CITY OF CRYSTAL LAKE
AGENDA
CITY COUNCIL
REGULAR MEETING
City of Crystal Lake
100 West Woodstock Street, Crystal Lake, IL
City Council Chambers
July 20, 2021
7:00 p.m.

<u>Meeting Date:</u>	July 20, 2021
<u>Item:</u>	REPORT OF THE PLANNING & ZONING COMMISSION
<u>Requests:</u>	Final Planned Unit Development Amendment and Special Use Permit for a new Gasoline Station with a Convenience Store, and Preliminary and Final Plat of Subdivision for a three-lot subdivision.
<u>Petitioner:</u>	Erik Nikkel, Casey's Retail Company, petitioner Ankeny, IA
<u>PZC Recommendation:</u>	Motion to approve the Planning and Zoning Commission (PZC) recommendation and adopt an Ordinance amending the PUD, granting a Special Use Permit and adopting the Preliminary/Final Plat of Resubdivision for a three-lot subdivision at 4220 Northwest Highway.
<u>Staff Contact:</u>	Michelle Rentzsch, Director of Community Development Elizabeth Maxwell, City Planner

**Casey's – Final Planned Unit Development Amendment,
Special Use Permit and Final Plat of Subdivision
Project Review for Planning and Zoning Commission**

LANDSCAPING PLAN
C-701

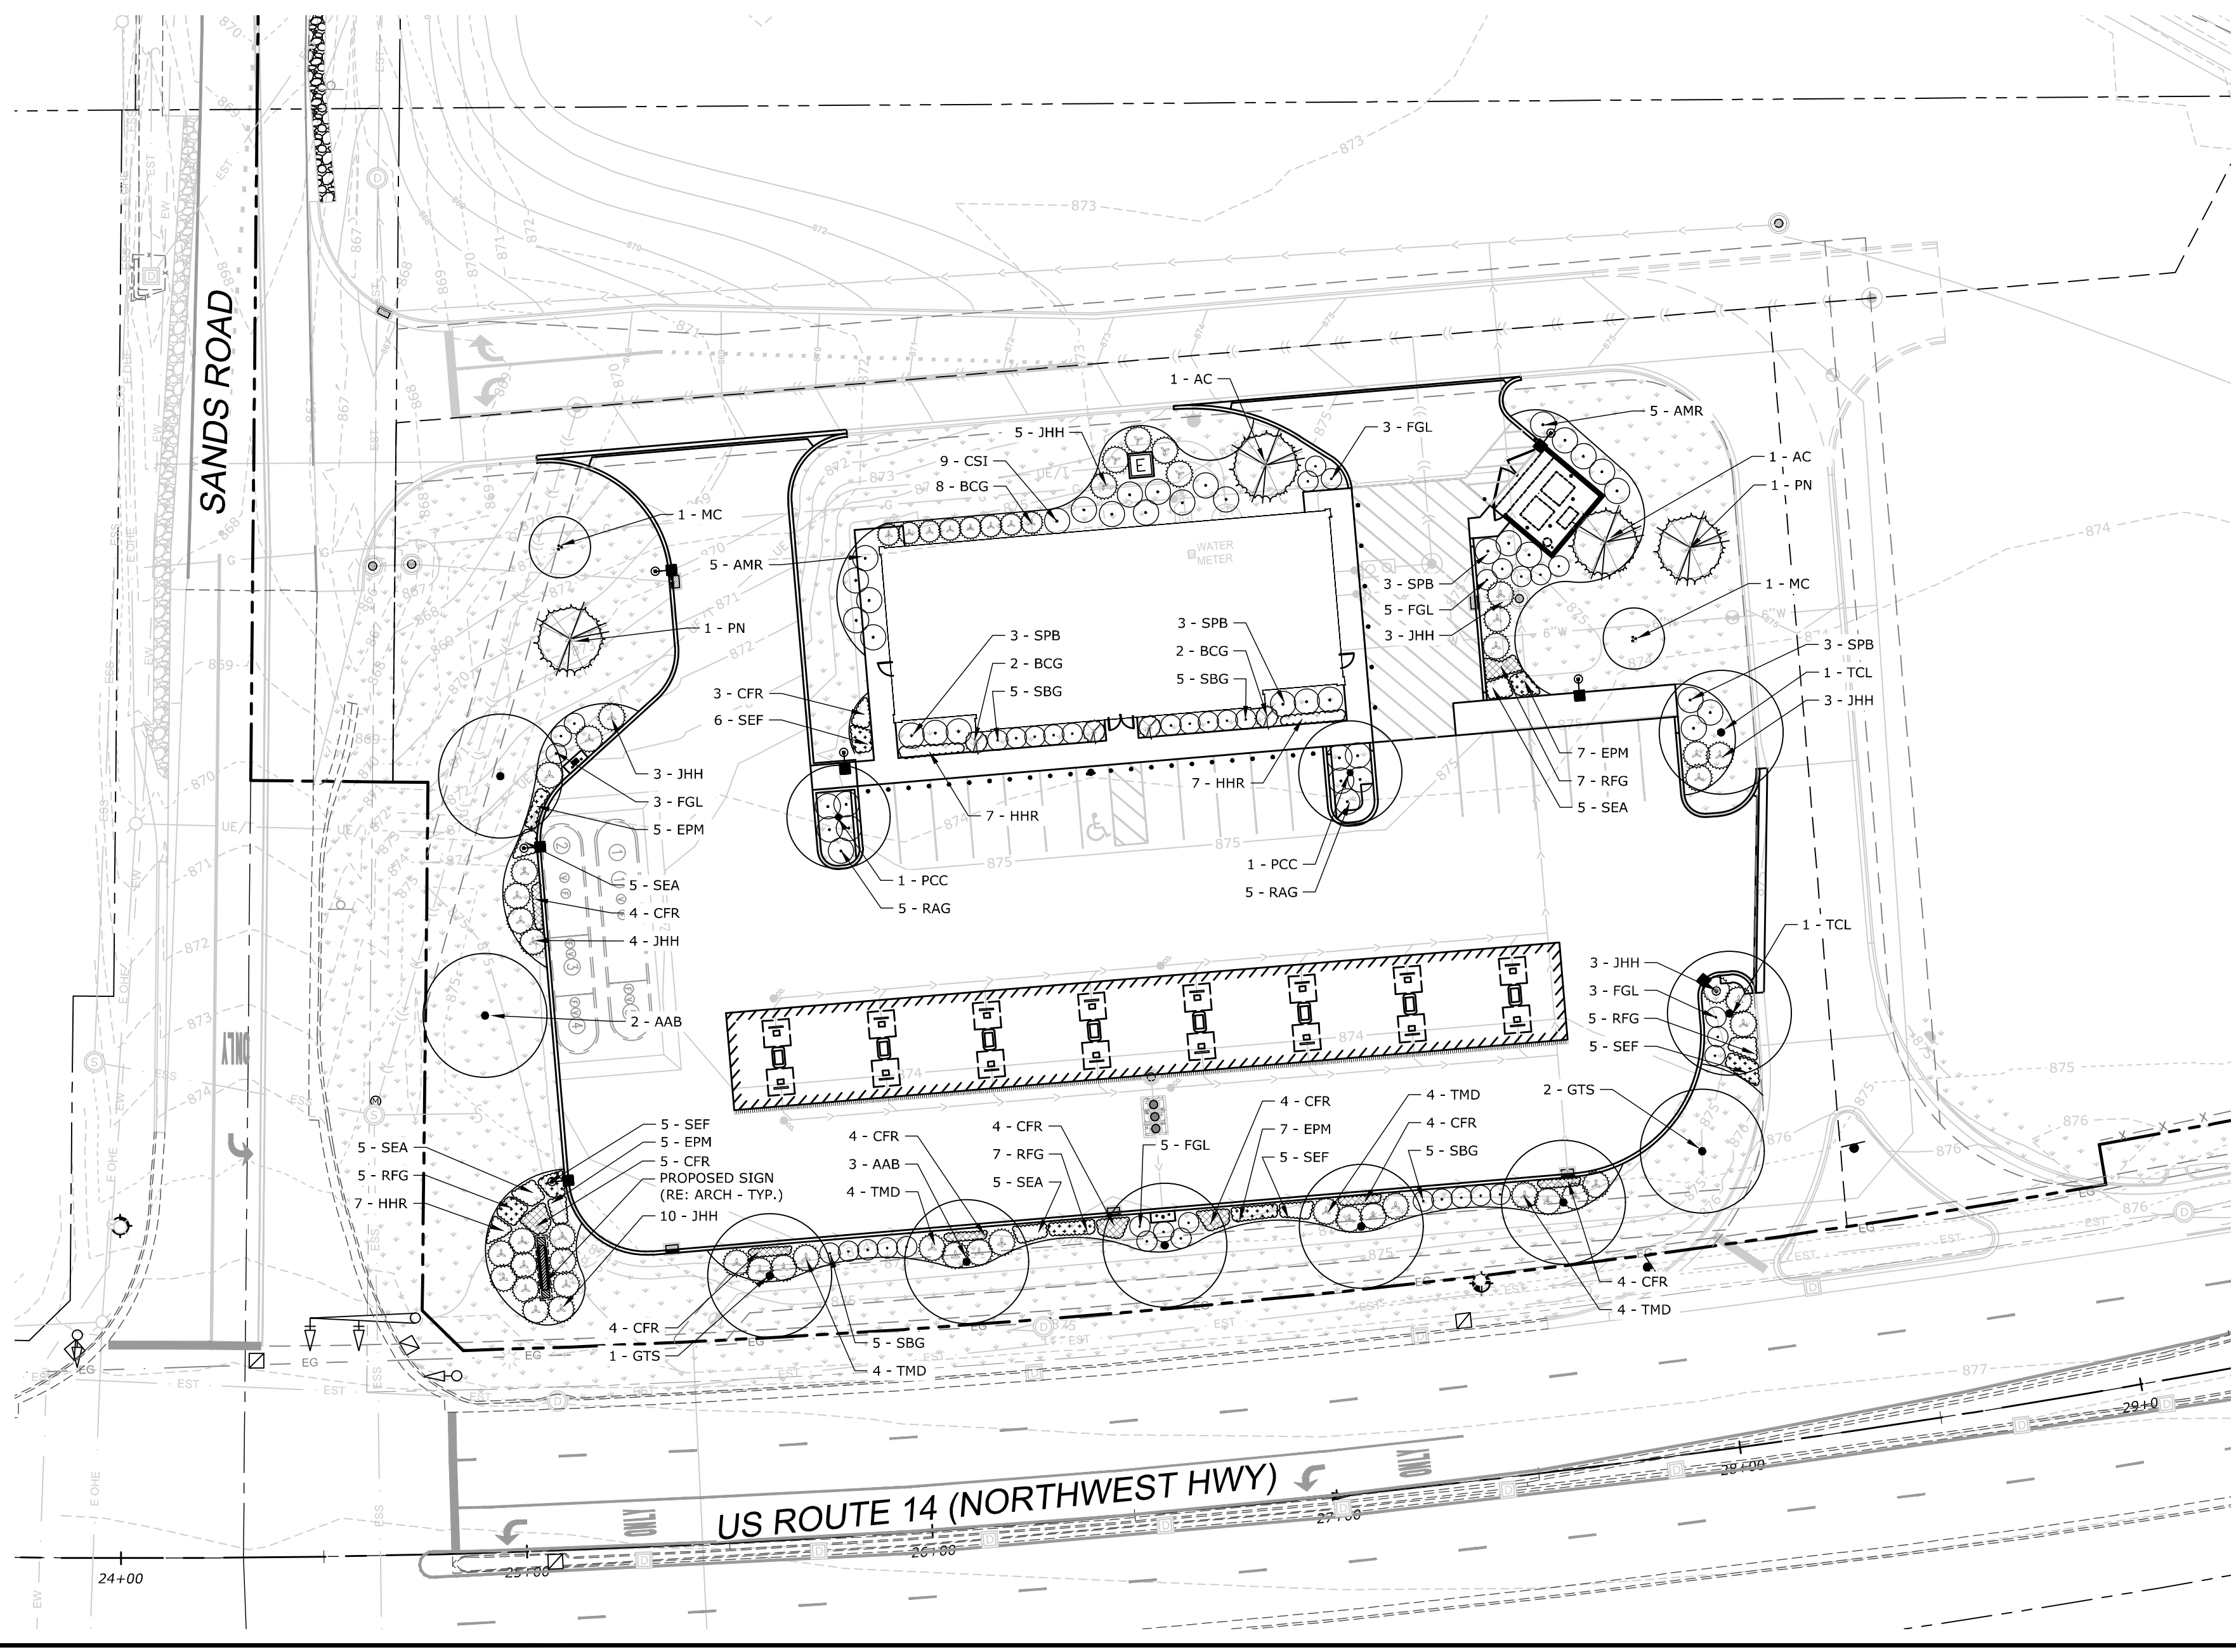
- Foundation Base plantings are required around the building at a minimum of 5 feet in width. Casey's is showing foundation base along the front and rear of the building. There is some landscape on the west side, which should be increased. The east side is reserved as a loading area. Landscape has been added to the opposite side of the loading area around the trash enclosure.
- The monument sign requires 1 square foot of landscape, which is illustrated in shrubs and flowers. Trees are also required, but a variation has been requested from this requirement.
- Casey's has done a good job of using a variety of landscape materials including trees on the interior of the site.

3. Landscape Plan
 - A. Add additional foundation base landscape along the west side of the building. Also landscape is shown over the sidewalk, correct the plans.

- B. Work with staff to increase the landscape area along Route 14 adding additional shrubs and plantings to screen the car headlights.
4. Elevations
 - A. Ensure the end columns at the front and rear of the building project out, creating a minimum 2-foot projection along the side and rear elevations to meet the design standards.

Landscaping quantities equivalent to the requested foundation and parking island landscaping variances are intended to be added to the northern portion of the development. Furthermore, additional plantings will be added along the US Rte 14 yard. To comply with the ordinance, an ornamental tree will be added near the monument sign located at the southwest corner of the site.

3. Landscape Plan
 - A. Work with staff to add foundation base landscape around the building and add additional landscape along Route 14.

FRONT ELEVATION

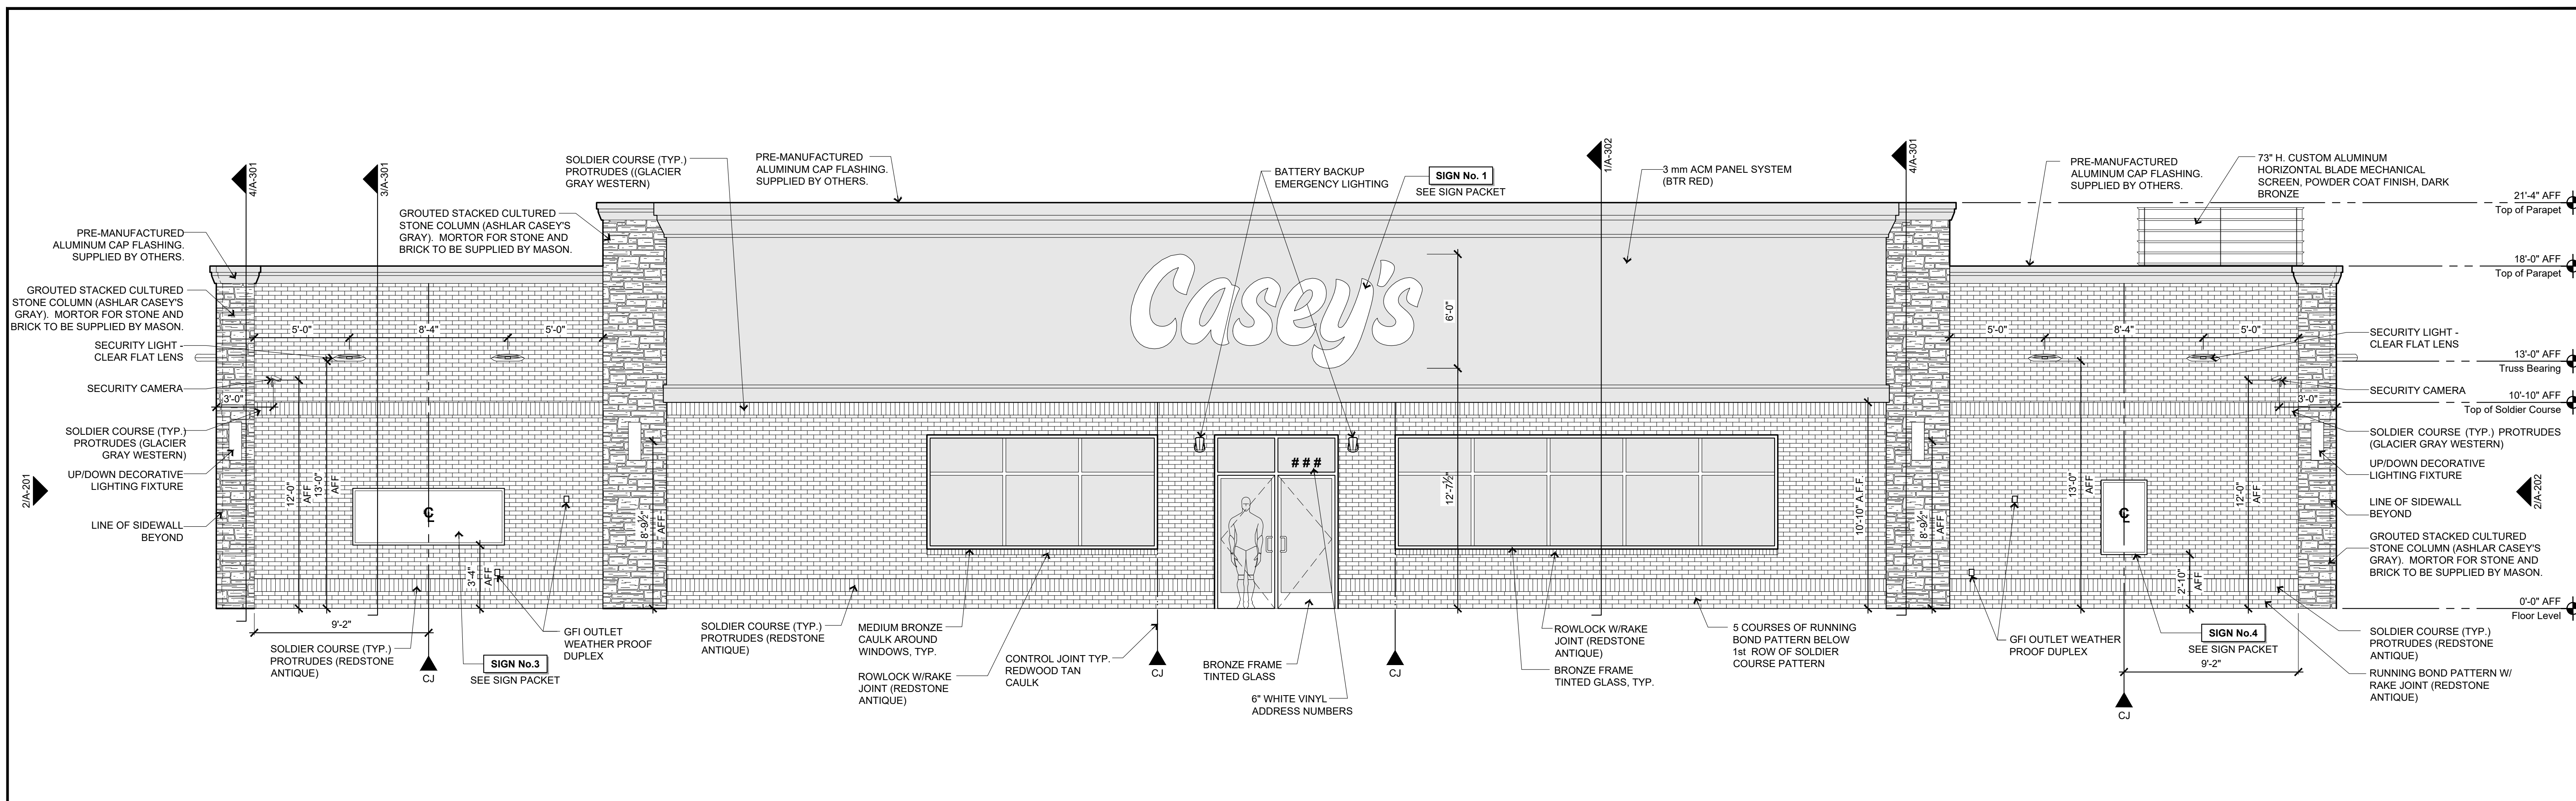
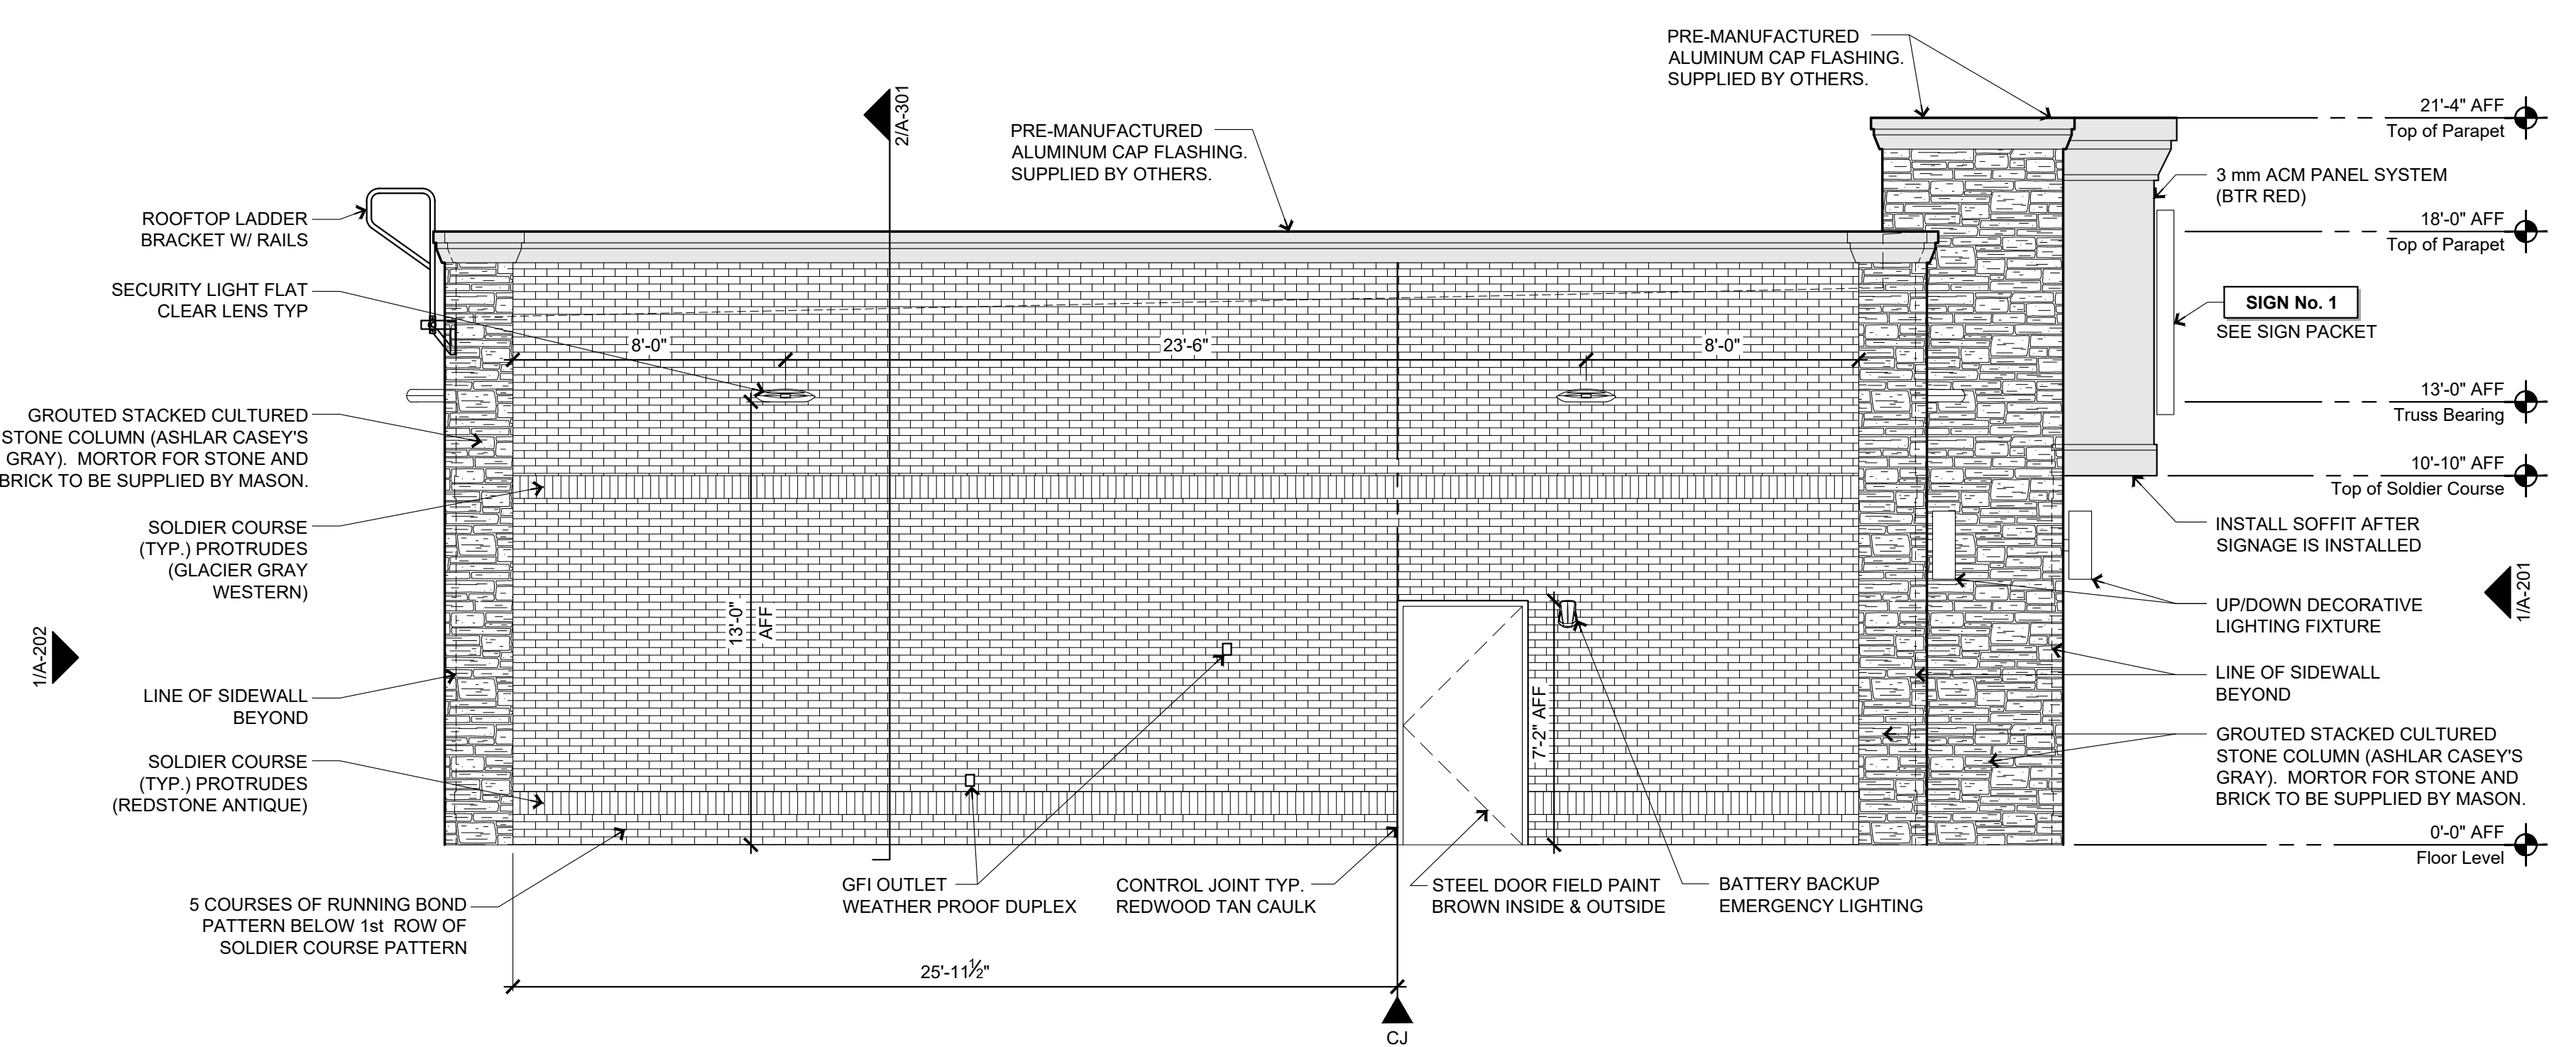
- Condition 8. This was added by the PZC. The front banding was not calculated as signage, but viewed as an architectural element. It is a metal panel system with a solid color exterior. To try to break up the panel with a third color or another material may look out of place. **The petitioner is requesting to keep the red paneling as proposed.**

In order to be more inline with other City approvals, staff is suggesting the petitioner made some change to the front red banding. There are two examples that would help meet the PZC's direction of breaking up the red area and/or reducing the red area size.

8. **Work with staff on a solution to break up the architectural element red paneling.** (Added by PZC)
 9. **Work with staff on site landscaping variations to come closer to compliance.** (Added by PZC)
